Date: 1 Sep 91
From: Kurt Chan
To: X3T9.2 Membership
Subject: Active Negation Drivers and Alt-2 Termination

X3T9.2/91-130R1

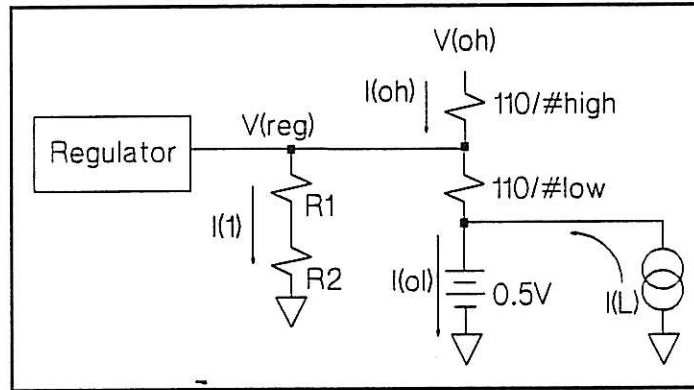
Al Wilhelm and Jeff Taylor from Adaptec recently pointed out a problem to me with single-ended SCSI. The problem has to do with some Alt-2 terminator designs allowing more than 44.8mA to flow to a SCSI signal when using active negation drivers:

Consider the case of multiple signals driving high and one wired-OR signal driving low. The equivalent circuit for this is shown above. Assuming the active negation drivers all drive to $V(oh)$ into their termination resistors, they have the potential to alter the regulator voltage.

This is because some low-dropout regulators use a "floating" design where a pass transistor is turned off if the output voltage exceeds 2.85V. Since the regulator will not sink any current in order to maintain regulation, it appears as an open circuit and allows the regulated voltage to rise. When this happens, any driver pulling down will be allowed to sink more than 48mA when its output voltage is at 0.5V.

One suggestion has been to specify $I(\text{oh})@V(\text{oh})$ for one or more voltages. However, this approach still allows the 48mA I_{OL} specification to be exceeded when several outputs are actively high. The conservative approach would therefore be to change the $V(\text{oh})$ specification from 5.25V to 3.25V for active negation drivers in section 6.1.1 (SPI):

V_{OL} (Low-level output voltage) = 0.0 to 0.5 volts dc at 48 mA sinking (signal assertion)
 V_{OH} (High-level output voltage) = 2.5 to 3.25 volts dc (active signal negation)
